FINAL DRAINAGE REPORT
for
SILVERADO RANCH FILING NO. 2

JPS Project No. 080603
SF-24-___

SILVERADO RANCH FILING NO. 2 – FINAL DRAINAGE REPORT
TABLE OF CONTENTS

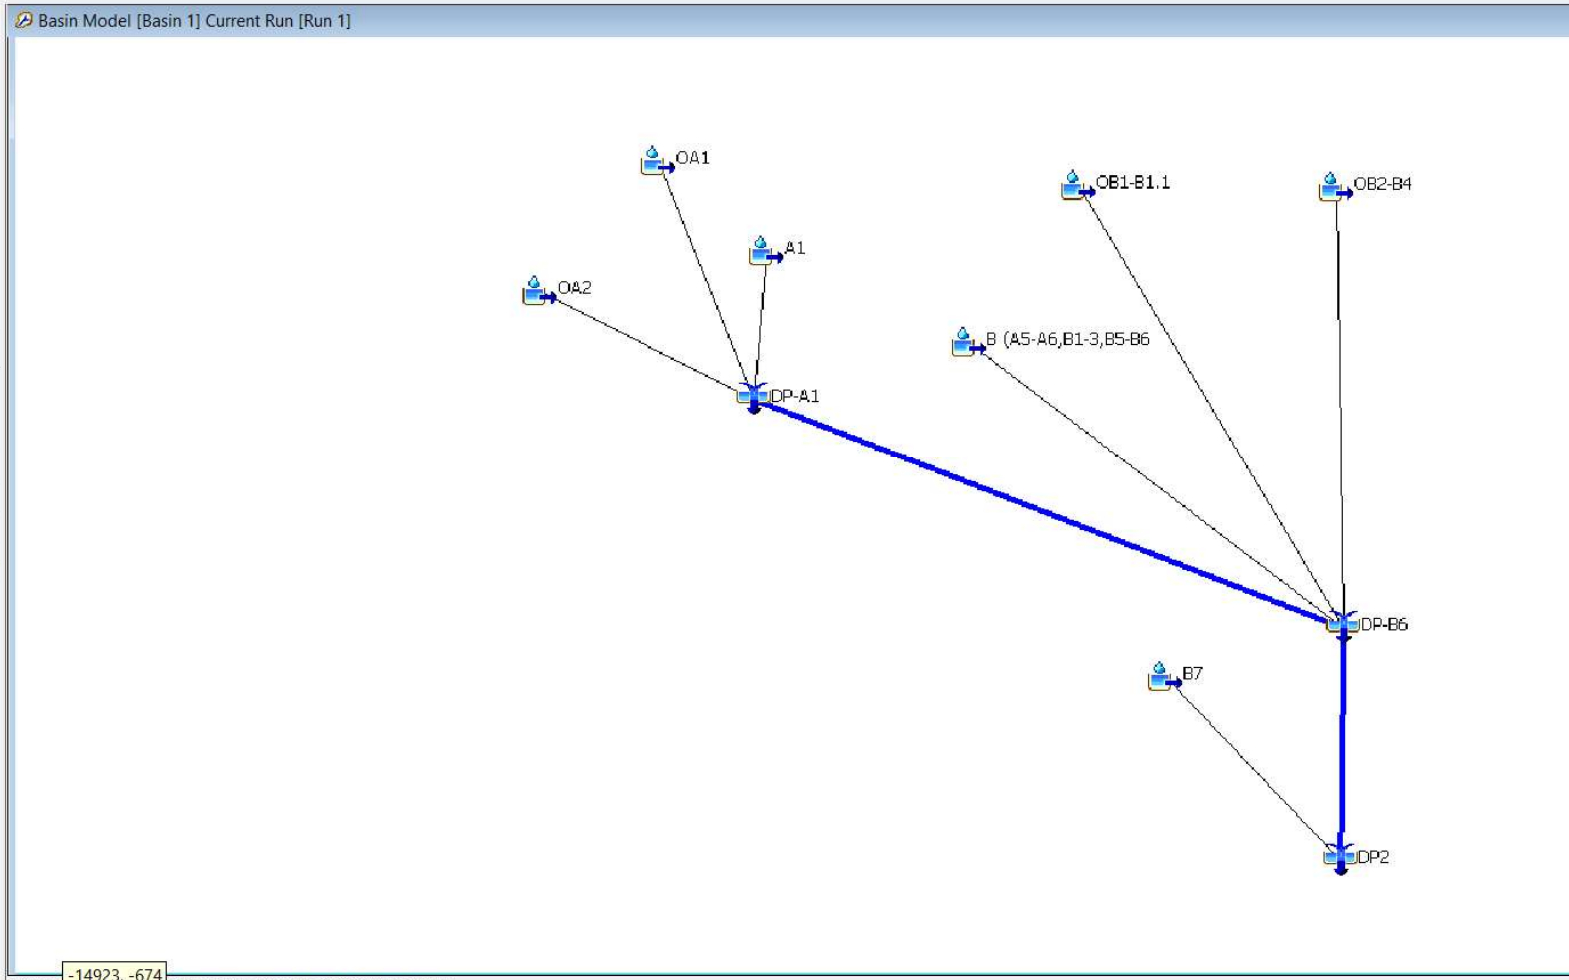
Add note to see other calculations spreadsheet for Basins A2, C & D and Design Points 1, 3 & 4

Per C/S DCM Chapter 6 Section 3.2.1, max overland length for non-urban land use is 300 ft. Please revise

SHEET: **EX1**

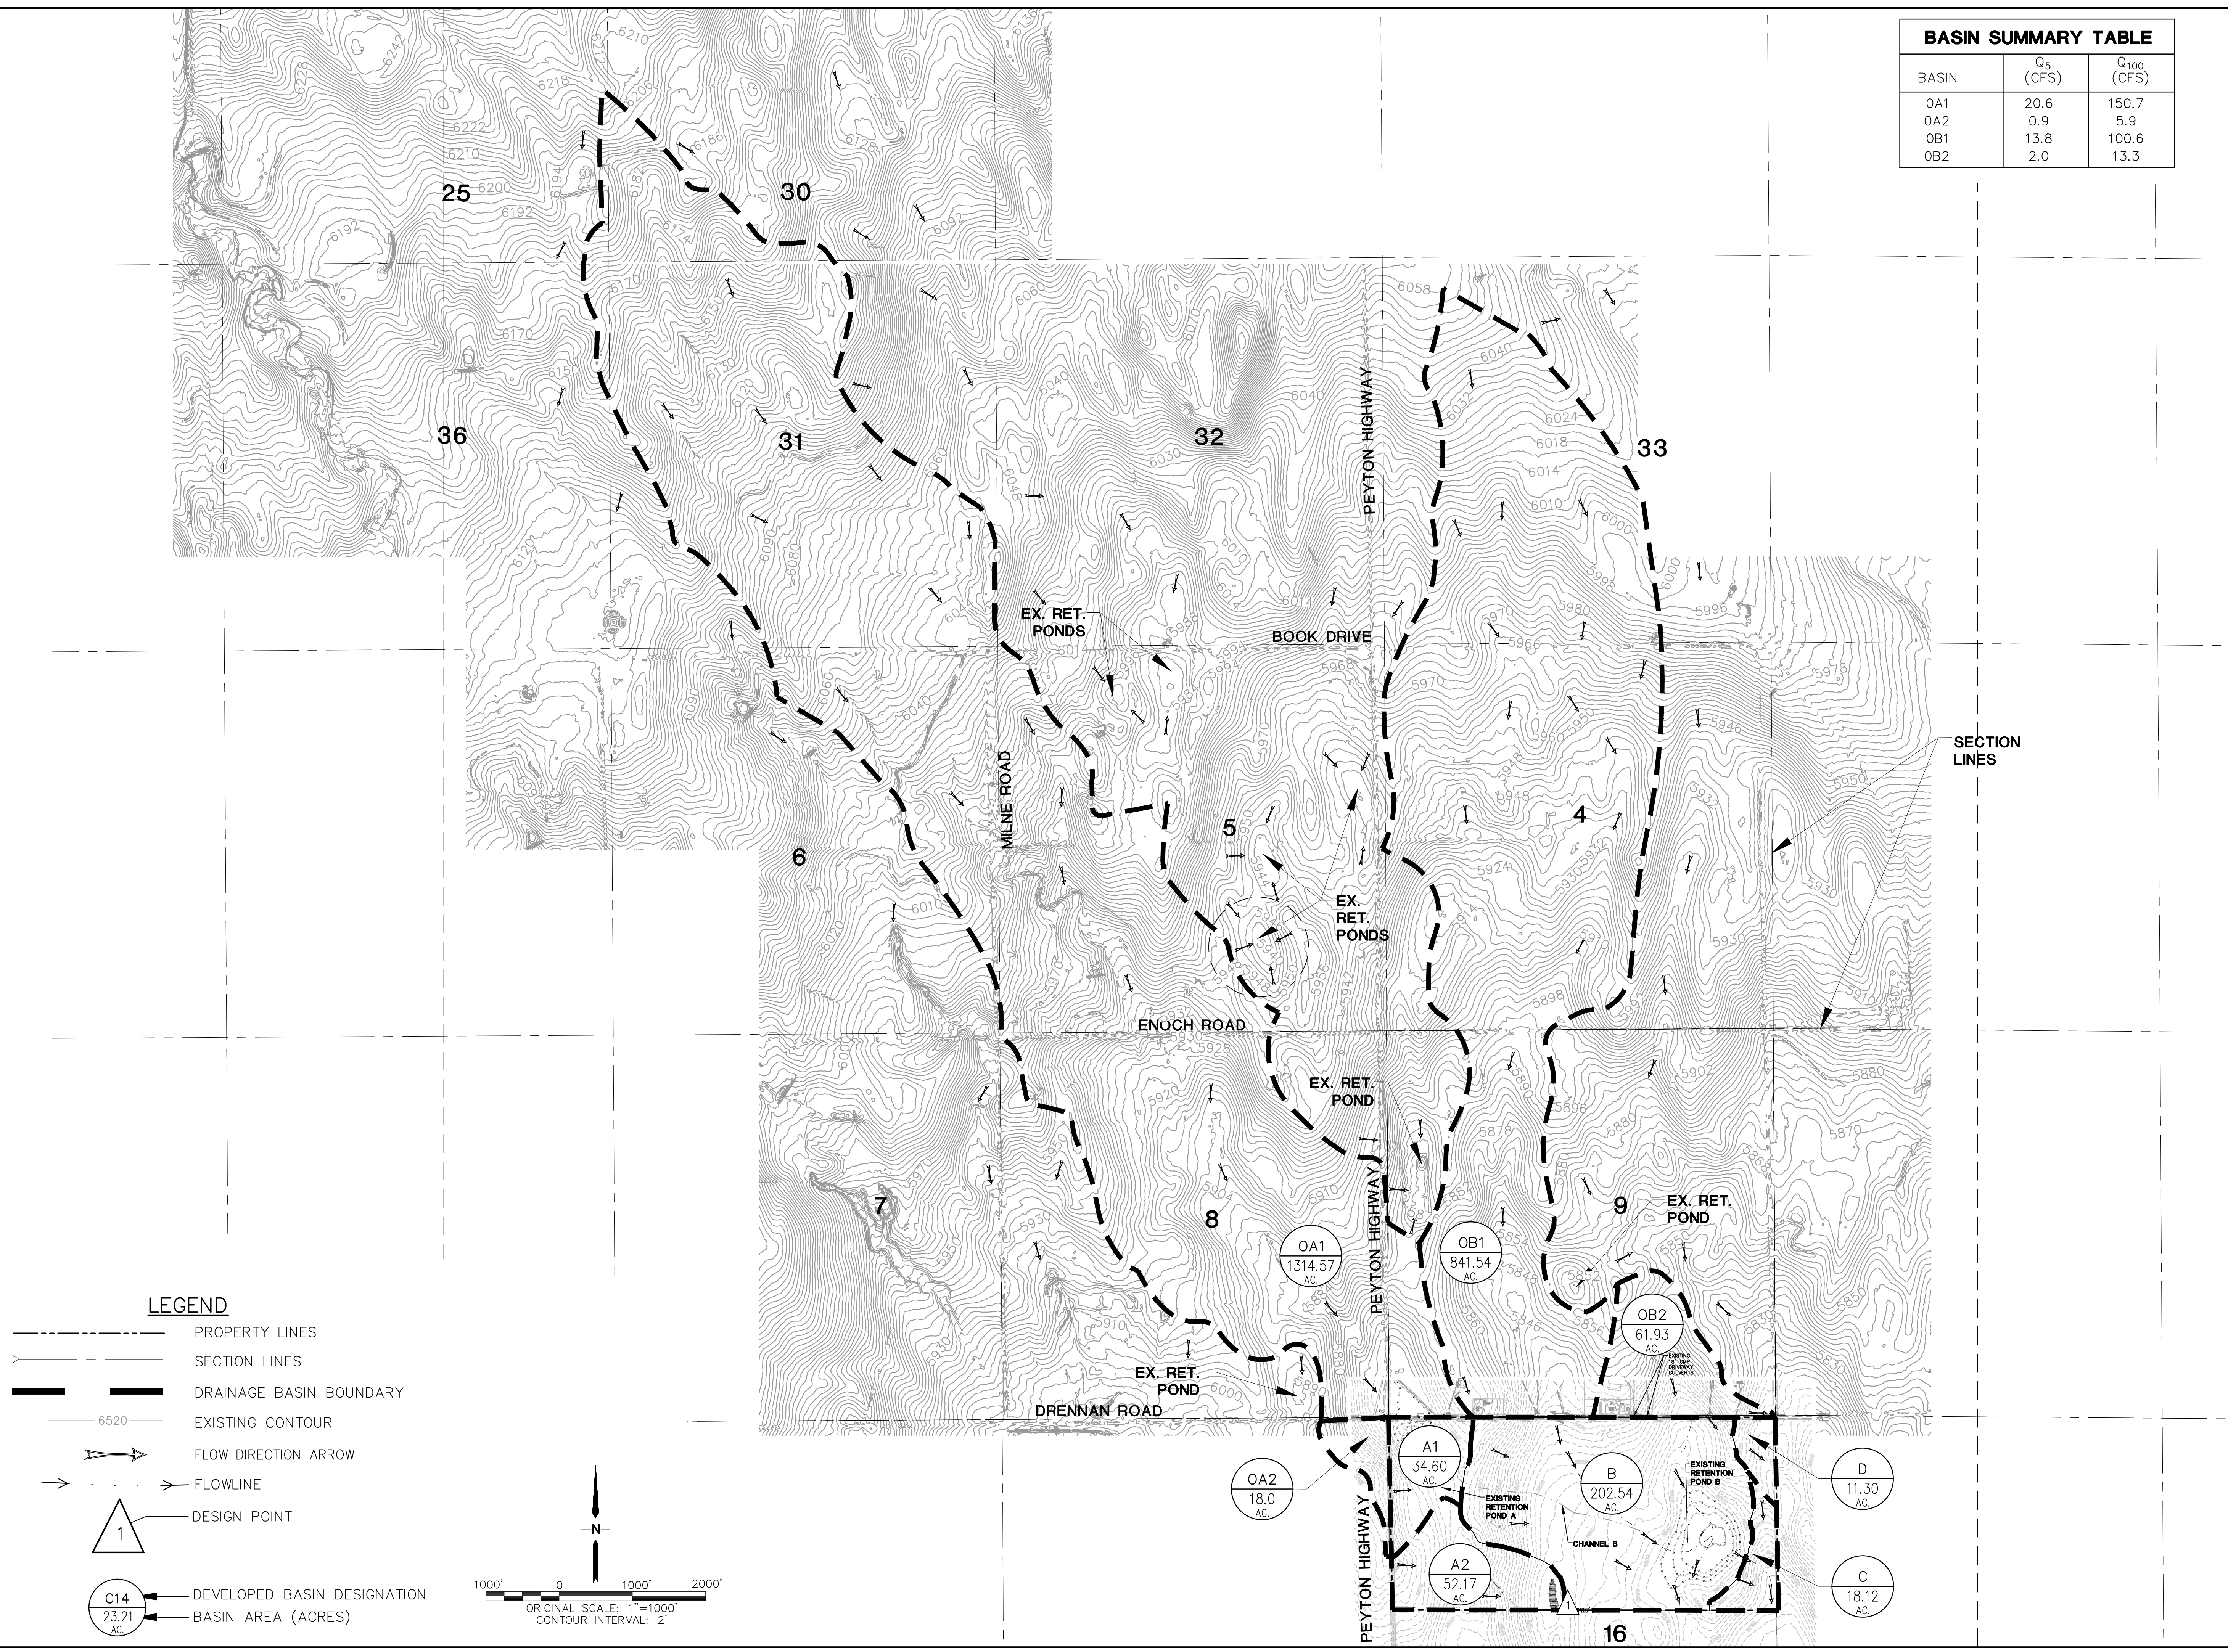
If the channel B3.1 existing, please show and label it on the existing map.

Please add directional flow arrow to Basin OA2.

Provide analysis of these 3 locations, showing the overtopping conditions.

HISTORIC DRAINAGE PLAN

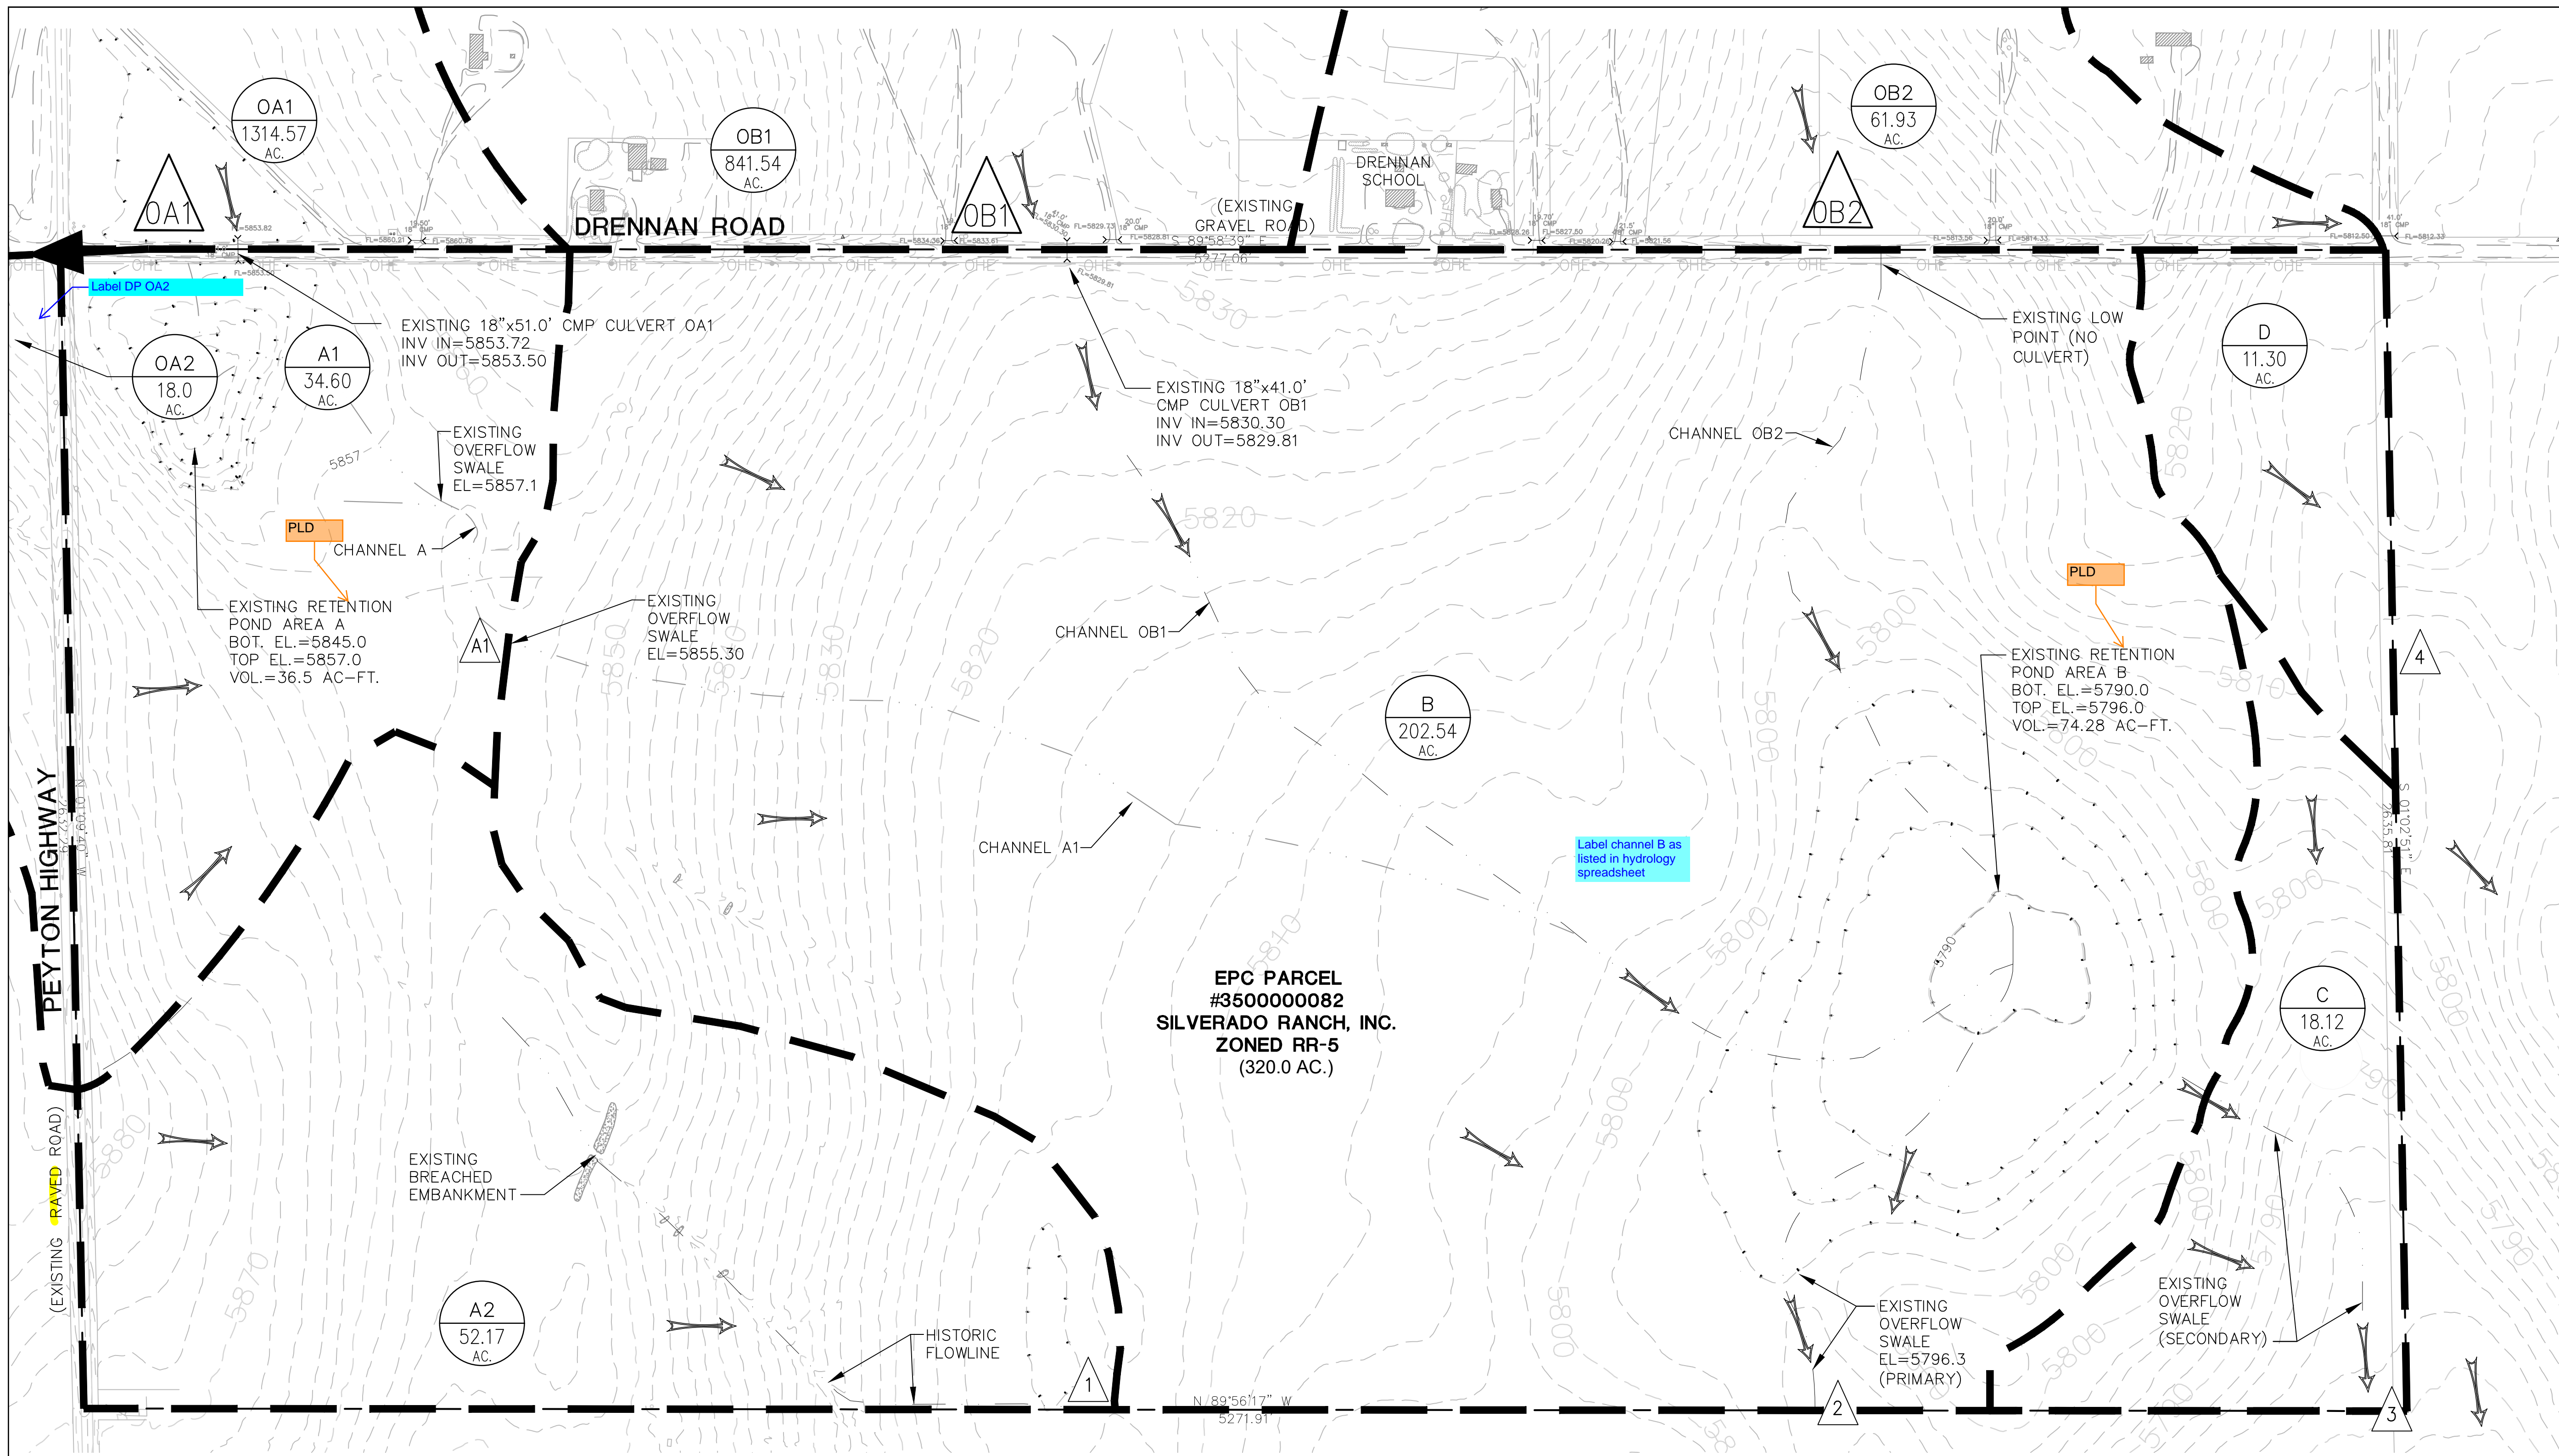
Include adjacent property owner information
